APPLICATION NO.	FILING DATE	FIRST NAMED INVENTOR	ATTORNEY DOCKET NO.	CONFIRMATION NO.
10/690,294	10/21/2003	Axel Grell	GK-EIS-1070 / 500593.2006	4580
26418	7590	10/19/2005	EXAMINER DABNEY, PHYLES HA LARVINIA	
REED SMITH, LLP ATTN: PATENT RECORDS DEPARTMENT 599 LEXINGTON AVENUE, 29TH FLOOR NEW YORK, NY 10022-7650			ART UNIT 2646	
PAPER NUMBER

Office Action Summary

DETAILED ACTION

FIG. 1

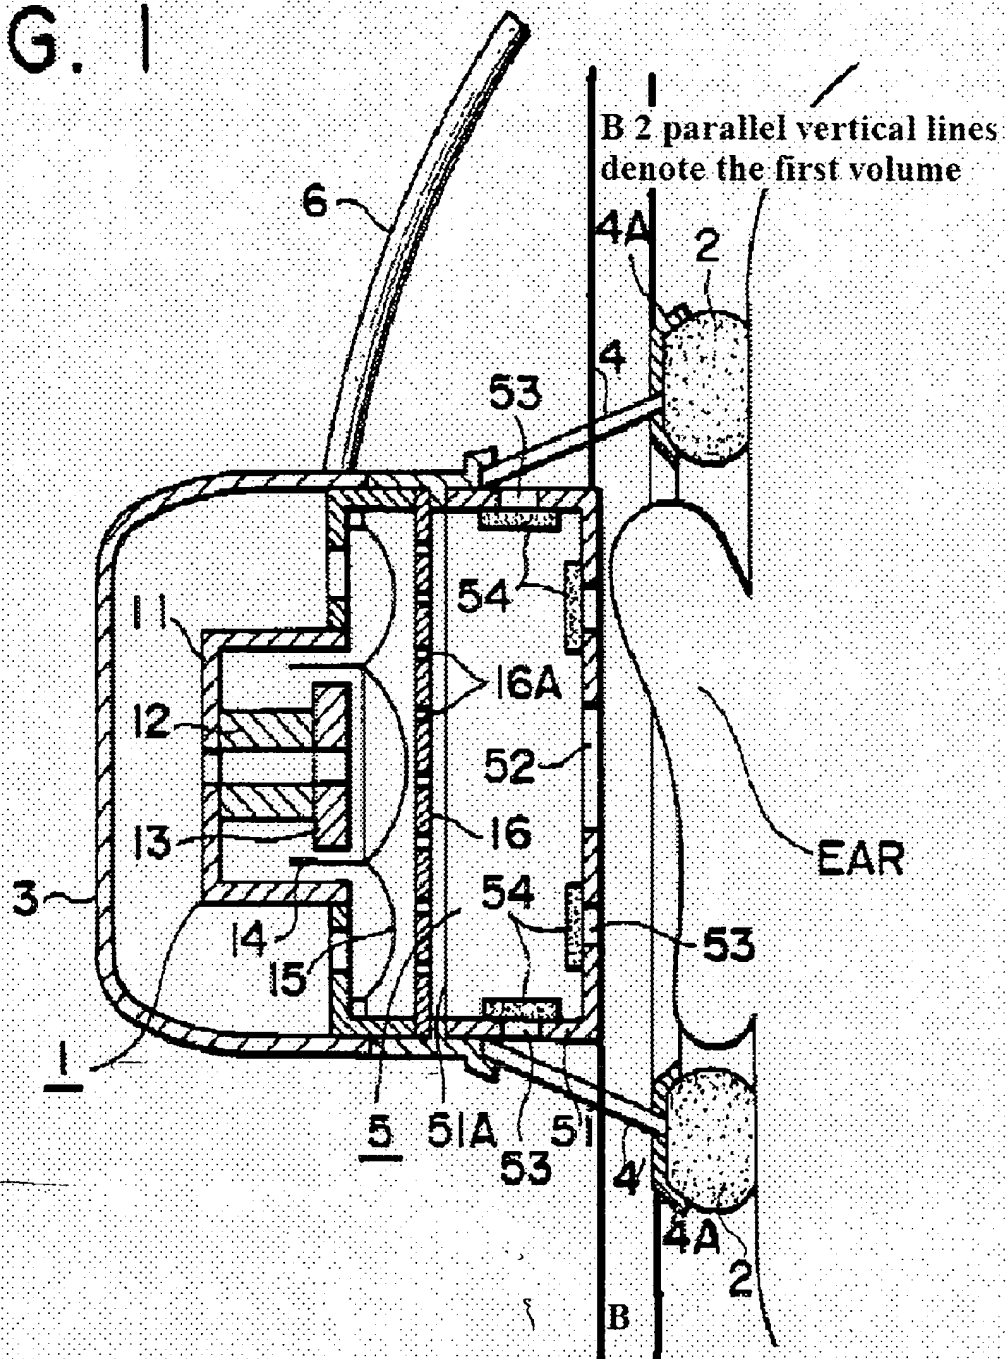
Regarding claim 1, Nageno teaches a headphones comprising: at least one headphone earpiece (figure 1-5C) having a housing (3); said earpiece (1) also having a reproduction system (11-15) and ear cushions (2), the latter enclosing the ear or lying on it, a front volume (area in front 53,54) and a rear volume (area behind 53,54) being determined by the reproduction system, the front volume being essentially the volume between the reproduction system and the volume enclosed by the ear cushions and the head (area in front 53,54) and the rear volume being essentially the volume enclosed by the reproduction system (area behind 53,54); and an acoustic resistor (54) connecting the housing of the headphone earpiece and the front and the rear volumes; said acoustic resistor (54) being situated inside the housing of the headphones earpiece with respect to the front volume behind a plane which is determined by a sound outlet aperture (53) of the housing.

Regarding claims 2-3, Nageno teaches the acoustic resistor (54) is situated inside a channel inside the housing of the headphones earpiece next to the reproduction transducer system.

• With respect to the applicant arguments that the Nageno reference does not teach the front volume corresponds to the volume between the reproduction system and the head of the wearer, while the rear volume corresponds to the volume between the reproduction system and the housing of the headphone ear piece, the examiner disagrees. Below is Figure 1 of Nageno. As stated in the office action, the first volume is the area in front of 53, 54 which corresponds to the area enclosed by the reproduction system and the ear cushion and head (designated as B below), and the rear volume is the area enclosed by the reproduction system and housing such

that the acoustic resistors (53, 54) reside in channel 51. Therefore, the rejection is maintained.
